Access Compliance Report

Public Rights-of-Way

(Curb Ramps)

Intersection ID: 24358	Main Street: CASHEL_CT	Cross Street: PRESCOTT_POND_LN	Location: SE
ADA ID: 8830A02081B8	Ramp Type: PerpDiag	Initial Pass/Fail: Fail	Overall Compliance: No
Severity Score: 13.75			
Codes/Mitigation Info/Possible Solution		Field Measurements/Component Compliance

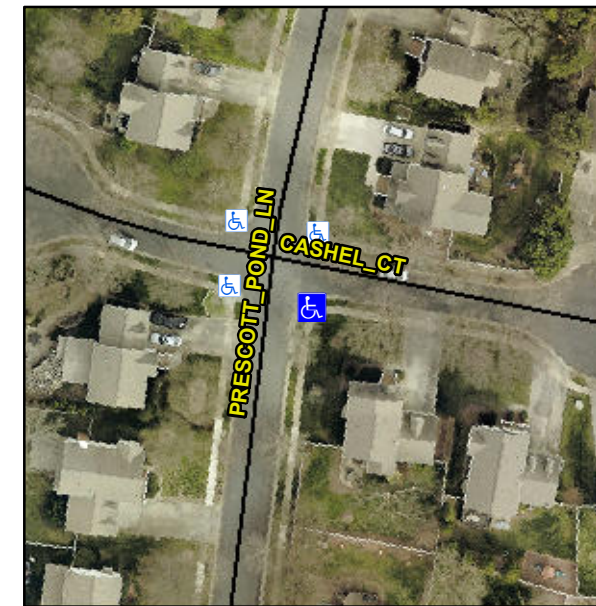
R304.2.2, R304.5.3

Compliance	Description	Data	Compliance	Description	Data
N/A	Ramp Length (in)	45.0	No	Ramp Slope (%)	9.0
Yes	Ramp Width (in)	55.0	No	Ramp XSlope (%)	2.4
N/A	Flare Type LT	N/A	N/A	Flare Type RT	N/A
N/A	Flare Slope LT (%)	N/A	N/A	Flare Slope RT (%)	N/A
N/A	Flare Traversable LT?	N/A	N/A	Flare Traversable RT?	N/A
N/A	Landing Length (in)	N/A	N/A	DWS Provided?	N/A
N/A	Landing Width (in)	N/A	N/A	DWS Contrast?	N/A
N/A	Landing Slope (%)	N/A	N/A	DWS Length (in)	N/A
N/A	Landing X Slope (%)	N/A	N/A	DWS Full Width?	N/A
N/A	Landing Curb? (Y/N)	N/A	N/A	DWS Offset (in)	N/A
N/A	Shared Landing?	N/A			
N/A	Gutter Ponding?	N/A	N/A	Gutter Slope (%)	N/A
N/A	Gutter Lip Ht (in)	N/A	N/A	Gutter X Slope (%)	N/A
N/A	Painted X Walk1?	No	N/A	Painted X Walk2?	No
	X Walk 1 Direction	To N		X Walk 2 Direction	To W
N/A	X Walk 1 Width (in)	N/A	N/A	X Walk 2 Width (in)	N/A
	X Walk 1 Slope (%)	2.8		X Walk 2 Slope (%)	4.0
	X Walk 1 X Slope (%)	1.7		X Walk 2 X Slope (%)	0.3

Remove & Replace Curb Ramp With Two New Directional Ramps or Equivalent.
